7-1– 12

Proposed Change as Submitted

Committee Action

TABLE 703.2.4—VISUAL CHARACTER HEIGHT

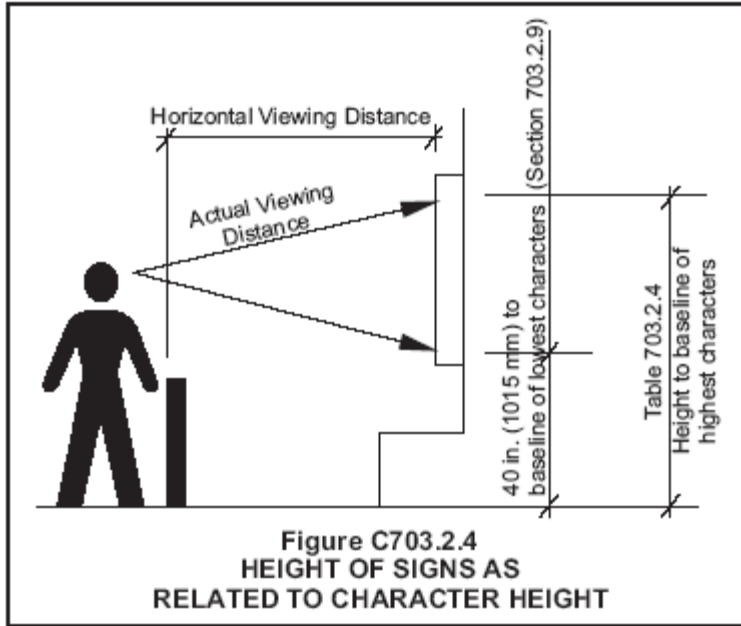
(Table 703.2.4) This proposal will clarify how the provisions are to be applied. Primarily the major revision needed is shown in footnote 1 of the table. If the committee desired, this footnote could be removed and the heading of the first column could be revised to read "Height above floor to baseline of characters on the highest line". Section 703.2.9 states that the minimum 40 inch height is "measured to the baseline of the character." That is acceptable since it is a minimum height requirement. That text does not however explain whether the ranges in the table (40 to 70, 70 to 120, or >120) is for the highest, lowest, average or each individual line of text. Therefore footnote 1 will clarify how the measurement is to be made and completes the information that is needed to comply with Section 703.2.9 which indicates "Heights shall comply with Table 703.2.4, based on the size of the characters on the sign". (Section 703.2.9 measures the minimum height to the lowest line of characters while Table 703.2.4 is measuring to the highest line of information when determining the minimum character heights.)

The following figure from the A117.1 commentary will help explain the intent of the change. It should also be noted that the commentary explaining Table 703.2.4 indicates the vertical height measurement to be used for determining the character height is taken "to the baseline of the highest line of the characters."

Height above Floor to Baseline of Character ¹	Horizontal Viewing Distance ²	Minimum Character Height
40 inches (1015 mm) to less than or equal to 70 inches (1780 mm)	Less than 6 feet (1830 mm)	⁵ / ₈ inch (16 mm)
	6 feet (1830 mm) and greater	⁵ / ₈ inch (16 mm), plus ¹ / ₈ inch (3.2 mm) per foot (305 mm) of viewing distance above 6 feet (1830 mm)
Greater than 70 inches (1780 mm) to	Less than 15 feet (4570 mm)	2 inches (51 mm)

1. The vertical height is measured from the floor of the viewing position to the baseline of the highest line of characters.
2. The horizontal viewing distance shall be measured as the horizontal distance between the character and an obstruction preventing further approach towards the sign or where applicable, as stated in the exception to Section 703.2.4.

TABLE 703.7.4—LOW RESOLUTION VMS CHARACTER HEIGHT

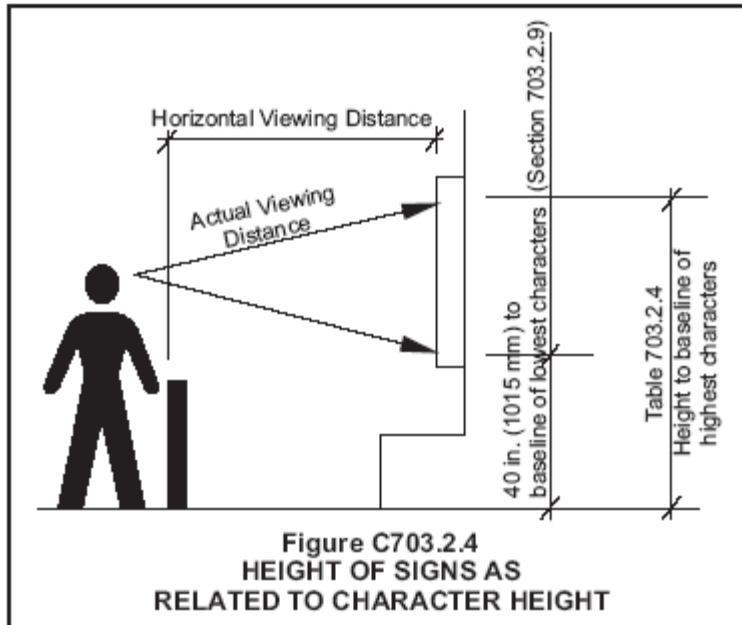
(Table 703.7.4) This proposal will clarify how the provisions are to be applied. Primarily the major revision needed is shown in footnote 1 of the table. If the committee desired, this footnote could be removed and the heading of the first column could be revised to read "Height above floor to baseline of characters on the highest line". Section 703.7.9 states that the minimum 40 inch height is "measured to the baseline of the character." That is acceptable since it is a minimum height requirement. That text does not however explain whether the ranges in the table (40 to 70, 70 to 120, or >120) is for the highest, lowest, average or each individual line of text. Therefore footnote 1 will clarify how the measurement is to be made and completes the information that is needed to comply with Section 703.7.9 which indicates "Heights of low resolution variable message signs characters shall comply with Table 703.7.4, based on the size of the characters on the sign". (Section 703.7.9 measures the minimum height to the lowest line of characters while Table 703.2.4 is measuring to the highest line of information when determining the minimum character heights.)

The following figure from the A117.1 commentary will help explain the intent of the change. It should also be noted that the commentary explaining Table 703.2.4 indicates the vertical height measurement to be used for determining the character height is taken "to the baseline of the highest line of the characters."

Height above Floor to Baseline of	Horizontal Viewing Distance ²	Minimum Character Height
40 inches (1015 mm) to less than or equal to 70 inches (1780 mm)	Less than 10 feet (3050 mm)	2 inches (51 mm)
	10 feet (3050 mm) and greater	2 inches (51 mm), plus $\frac{1}{5}$ inch (5.1 mm) per foot (305 mm) of viewing distance above 10 feet (3050 mm)
Greater than 70 inches (1780 mm) to less than or equal to 120 inches (3050 mm)	Less than 15 feet (4570 mm)	3 inches (75 mm)
	15 feet (4570 mm) and greater	3 inches (75 mm), plus $\frac{1}{5}$ inch (5.1 mm) per foot (305 mm) of viewing distance above 15 feet (4570 mm)
Greater than 120 inches (3050 mm)	Less than 20 feet (6095 mm)	4 inches (100 mm)
	20 feet (6095 mm) and greater	4 inches (100 mm), plus $\frac{1}{5}$ inch (5.1 mm) per foot (305 mm) of viewing distance above 20 feet

1. The vertical height is measured from the floor of the viewing position to the baseline of the highest line of characters.
2. The horizontal viewing distance shall be measured as the horizontal distance between the character and an obstruction preventing further approach towards the sign or where applicable, as stated in the exception to Section 703.7.4.
